1998 - 1999 Corvette: Service Bulletin: Tech - Service Engine Soon (SES) Light Illuminates (Repl Switch Assy)

Source: Chevrolet Dealer Technical Service Bulletin

Number: 99-07-30-013

with Hydra-Matic 4L60-E Transmission (RPO M30)

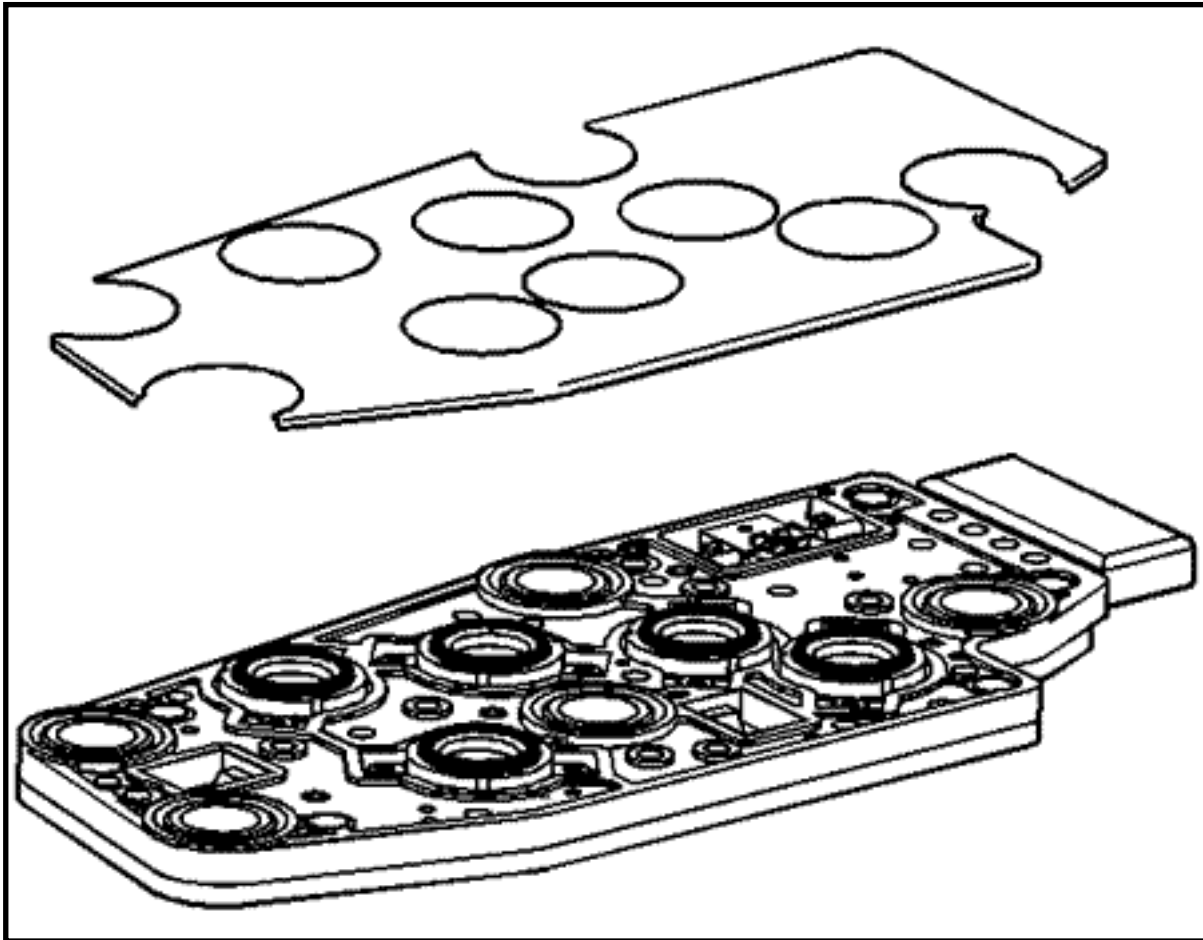
Debris from aluminum shavings, bronze material, and certain clutch material may cause the pressure switches in the TFP switch assembly to stick or electrically short out.

A new TFP switch assembly with a plastic shield has been released. The plastic shield is designed to protect the pressure switch from debris. This improvement will reduce the likelihood of a DTC P1810. This product change went into production on April 8, 1999 (Julian date 098). The existing TFP switch assembly remains relatively unchanged except for the addition of the new shield, creating a new part number for the assembly. The shield fits over the existing TFP switch assembly and is not sold separately.

Follow diagnostics for the P1810 Diagnostic Trouble Code in the Transmission Section of the appropriate Service Manual. If the diagnostics indicate that switch replacement is necessary, use the correct switch P/N as listed below.

Part Number	Usage	Description
24215111	1998-1999	TFP Switch Assembly with Shield
